Bayside Planning Panel

Item No	6.6
Application Type	Development Application
Application Number	DA-2017/105
Lodgement Date	28 September 2016
Property	109-110 The Grand Parade, Brighton Le Sands
Owner	The Prop of Strata Plan 1727
Applicant	Mr C Hafouri
Proposal	Construction of a four (4) storey residential flat building containing 11 apartments, basement level parking, private and communal roof top terrace areas and demolition of existing structures
No. of Submissions	41 (A total of ten (10) submissions were received during the last notification period)
Cost of Development	\$5,302,943.00
Report by	Alexandra Hafner – Senior Assessment Planner

Planning Assessment Report

Application Number:	DA-2017/105
Date of Receipt:	28 September 2016
Property:	109 - 110 The Grand Parade, BRIGHTON LE SANDS (SP 1727)
Owner:	The Prop Of Strata Plan 1727
Applicant:	Mr Carlos Hafouri
Proposal:	Construction of a four (4) storey residential flat building containing 11 apartments, basement car parking, private and communal roof top terrace areas and demolition of existing structures
Recommendation:	Approved
No. of submissions:	41 letters (A total of ten (10) submissions were received during the last notif

4.3 Height of buildings

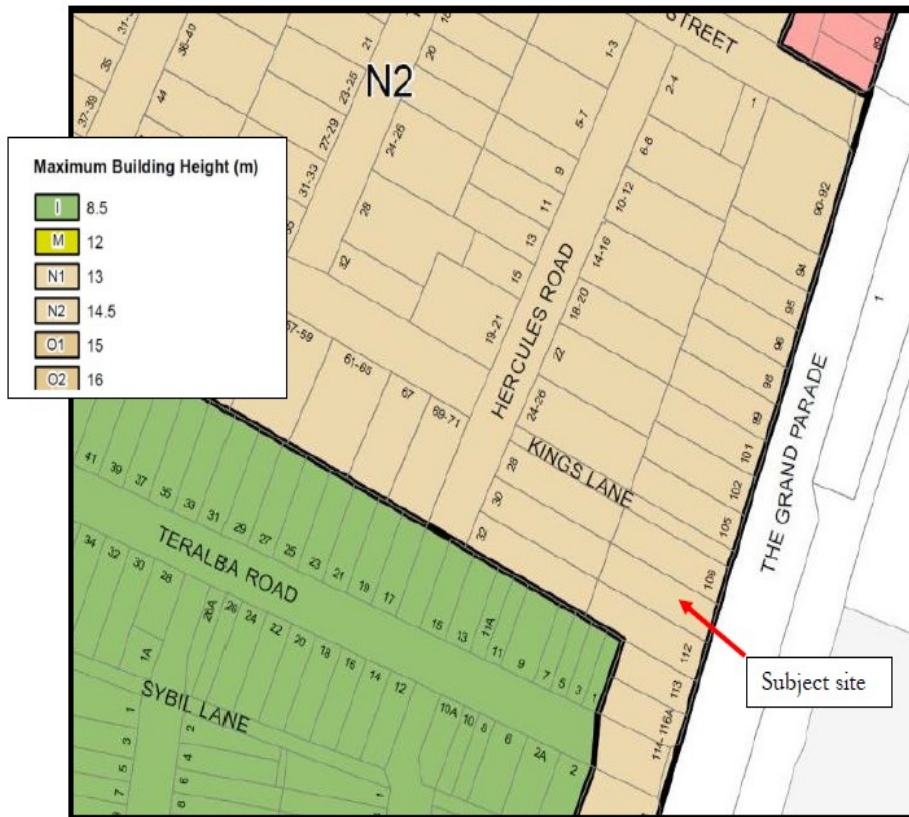
The proposed development seeks a maximum building height of 14.8 metres (RL 21.3 - RL 6.5) to accommodate the top of lift/stair overrun and therefore exceeds the maximum permitted by 300mm. This represents a 2% variation to the numerical development standard. The application is accompanied by a revised and written Clause 4.6 submission seeking to vary the numerical provisions of this Clause, the merits of which are discussed below.

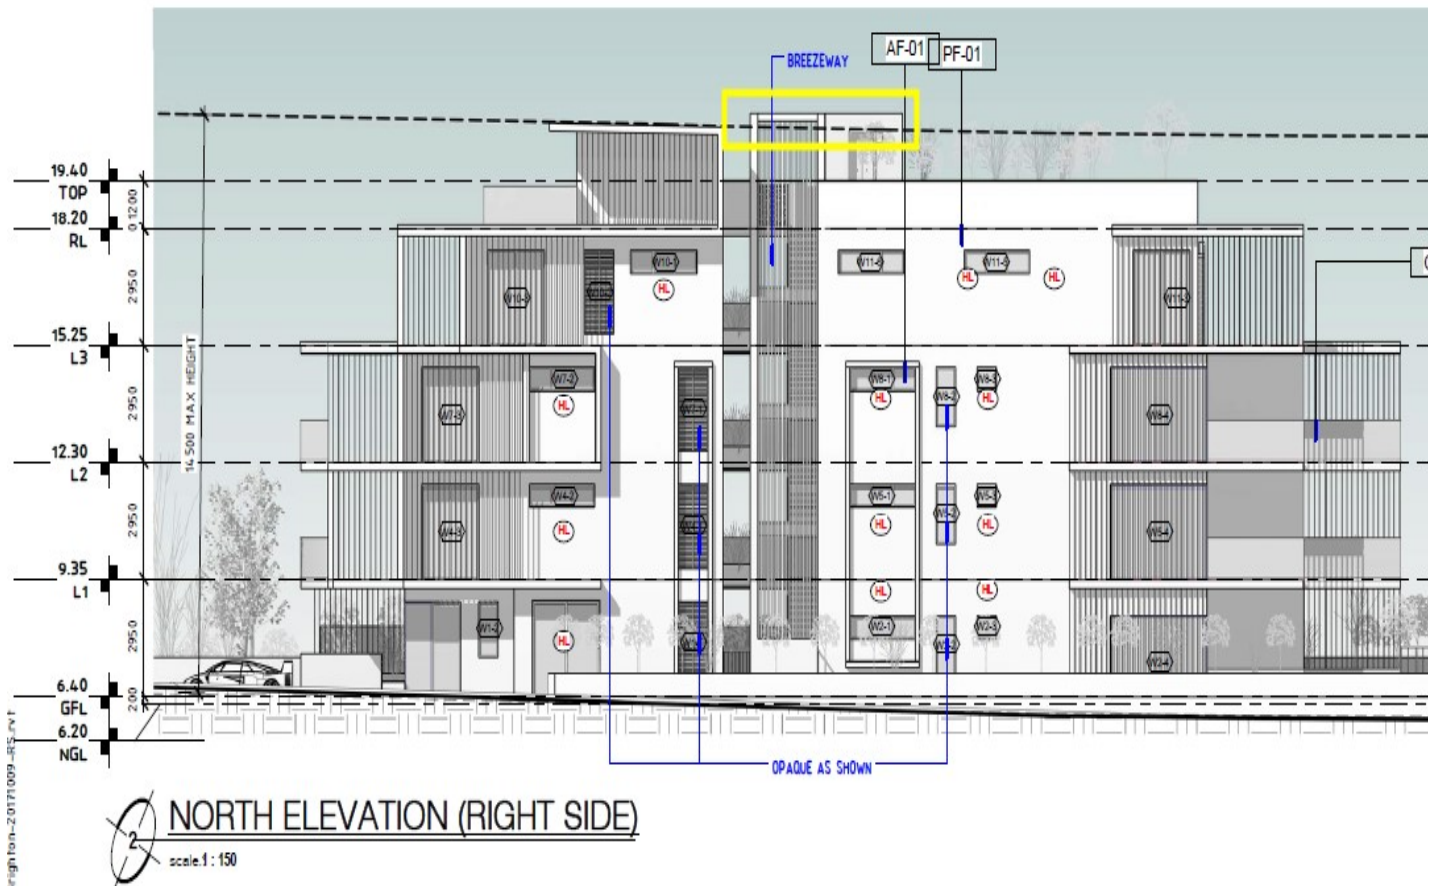
As noted within Clause 4.3 Height of Buildings, the proposal seeks to vary the maximum 14.5m height standard applicable to the subject site by 0.3m to accommodate the top of the lift / stair overrun. This equates to a variation of 2% to the maximum permissible height limit on site and is shown in yellow in the figure below.

4.4.2 Solar Access - Residential Flat Buildings and Shop Top Housing

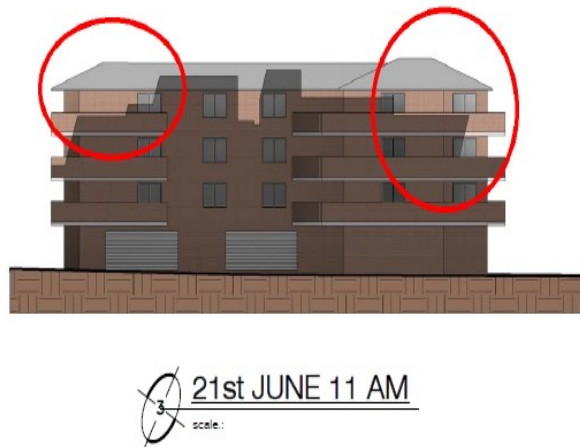
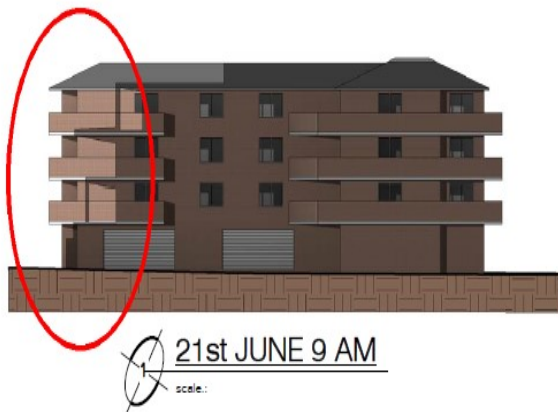
Comment: Elevational shadow diagrams, Drawing No's. DA611 and DA612, were submitted by the applicant in order to demonstrate the resultant overshadowing impacts of the proposal in midwinter onto the six (6) units within the southern adjoining neighbouring building at 112 The Grand Parade. The matter of overshadowing has been discussed in detail within Part 4.42 of this report and deemed acceptable in this regard.

DRIVEWAY/SWEPT PATH PLAN

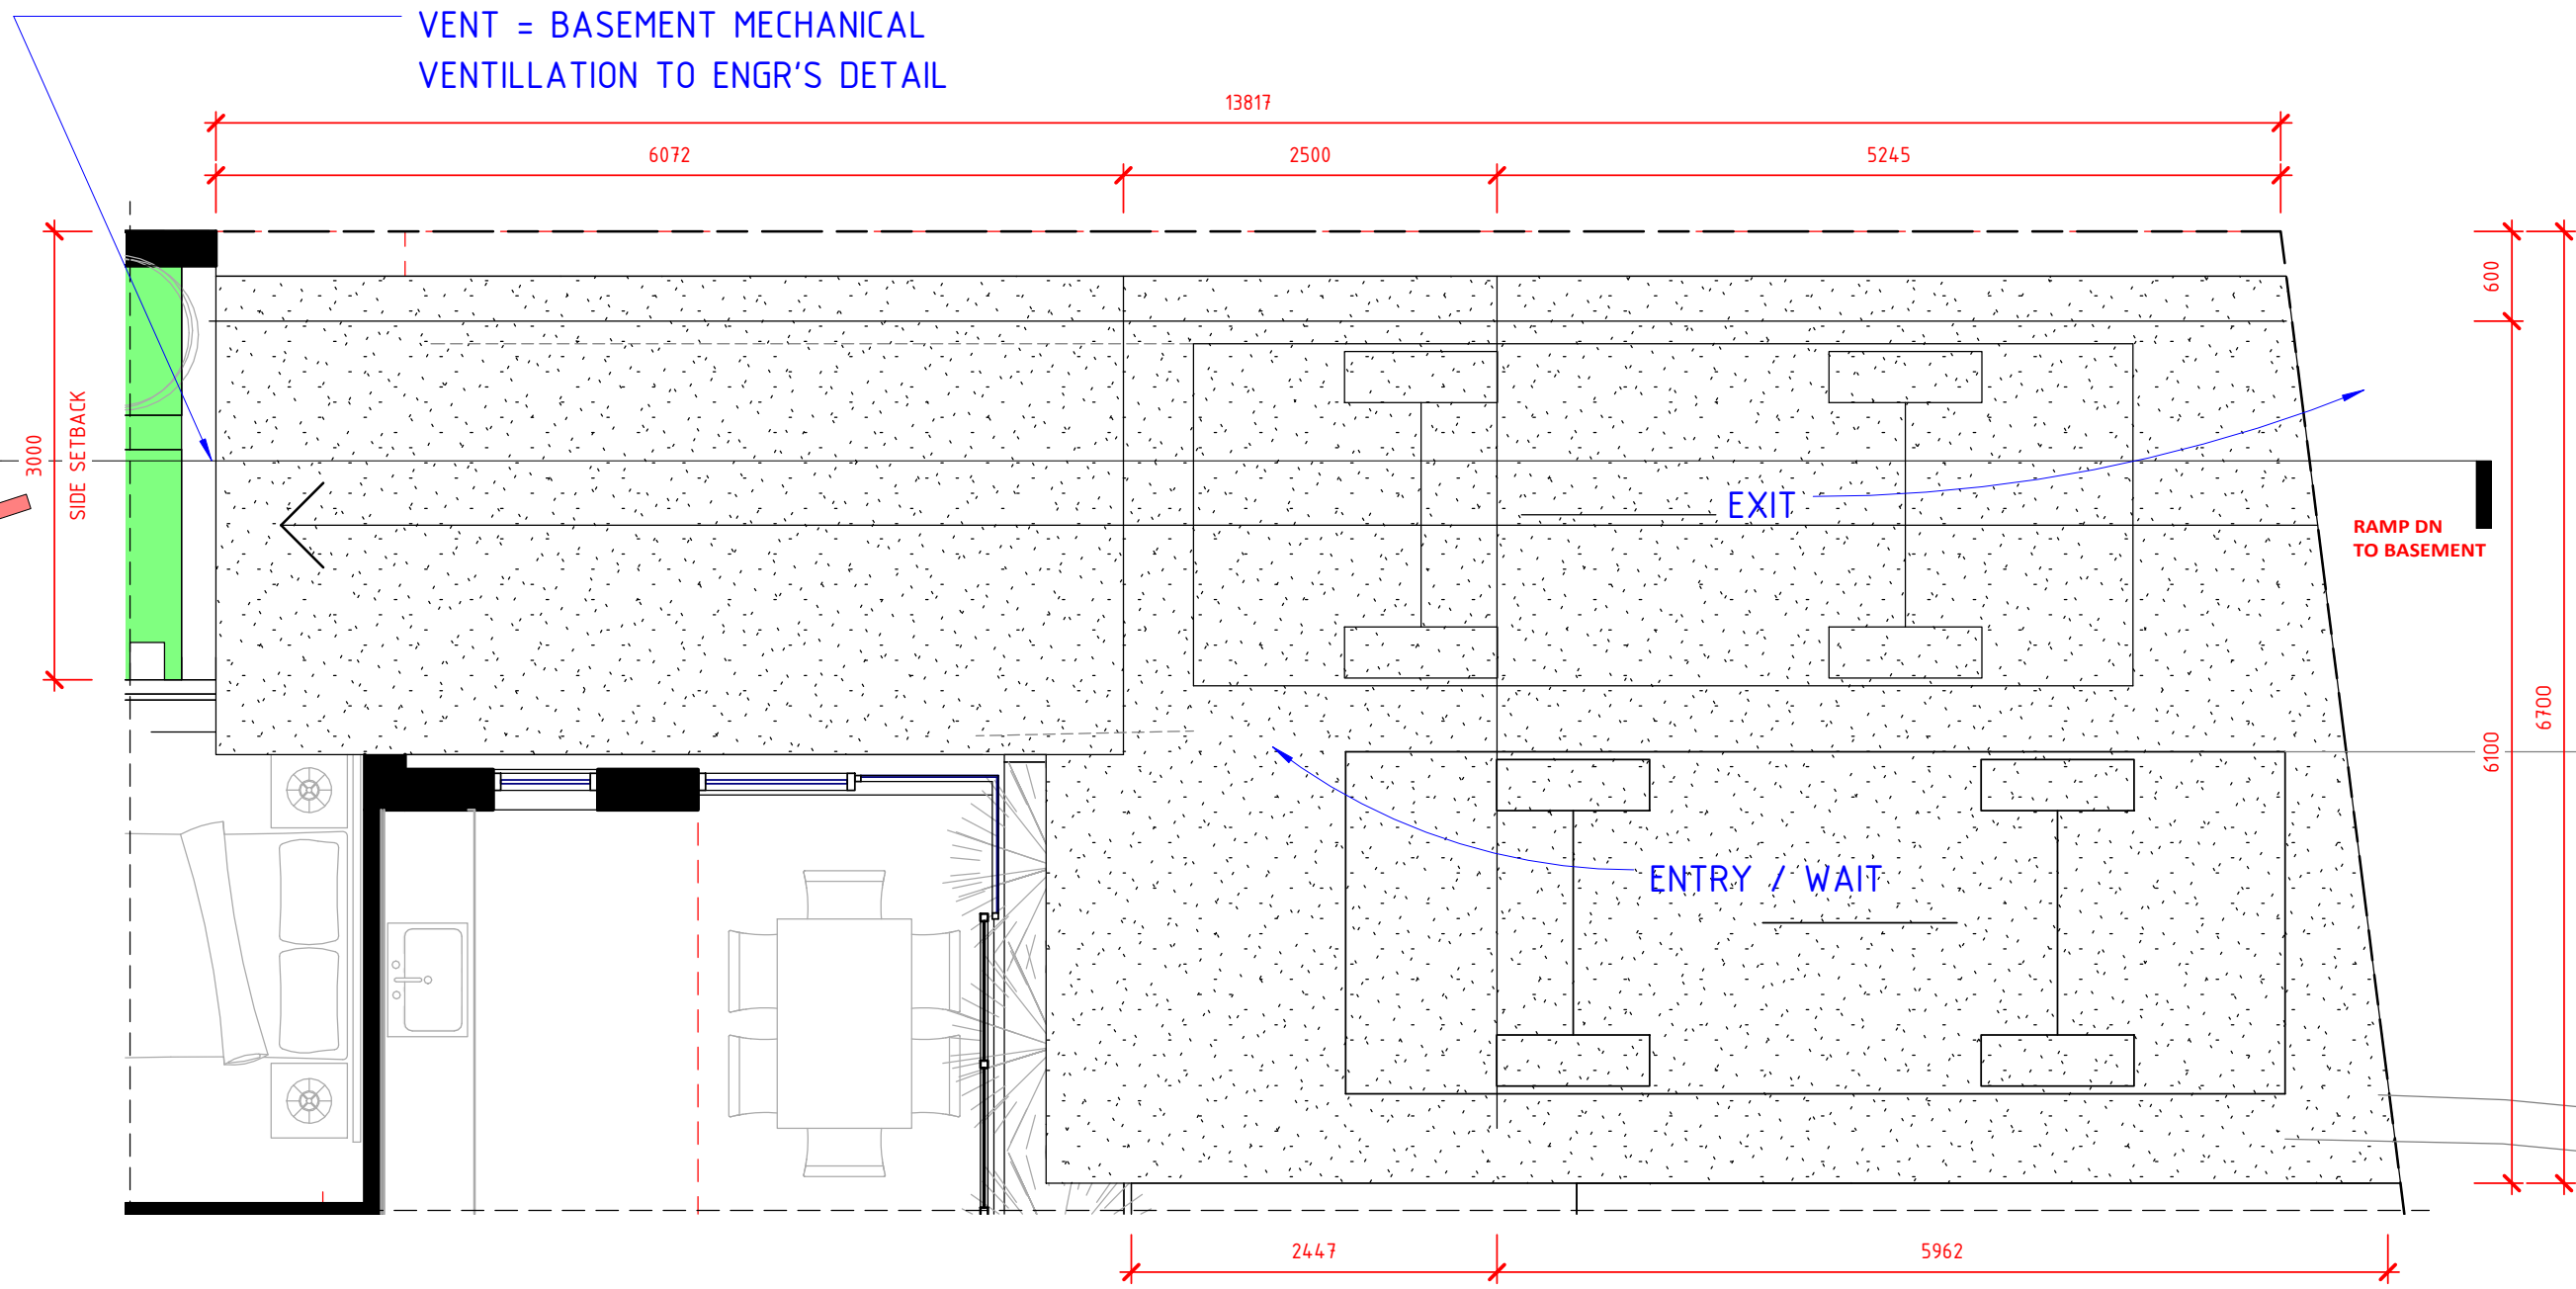
1. The driveway is to be 5.5m wide at the crossover on The Grande Parade and for at least 6 metres from the property boundary in accordance Australian Standards. Therefore the site/ground floor plans should be amended to show the proposed driveway being at least 5.5m in width at the crossover on The Grand Parade, and for 6 metres into the site. The maximum grade for the first 6 metres from property boundary shall be 1 in 20 (5%). This will allow vehicles to enter and exit the property simultaneous. Furthermore, this will reduce impact on the traffic movements on The Grand Parade as vehicles don't have to be stationary and wait on The Grand Parade.

As noted above, the RMS did not support the provision of the proposed dual SRV loading / unloading and passing bay within the front setback of the site. Revised architectural plans, Issue 6 and dated 9 October 2017, show this to be relocated to Basement Level 1 with the provision of two (2) spaces. The crossover has been increased to 6.1m with the area within the primary setback used as a passing bay only. Subject to conditions, the proposal considered to be satisfactory with regards to the requirements of Clause 101 of the SEPP (Infrastructure).
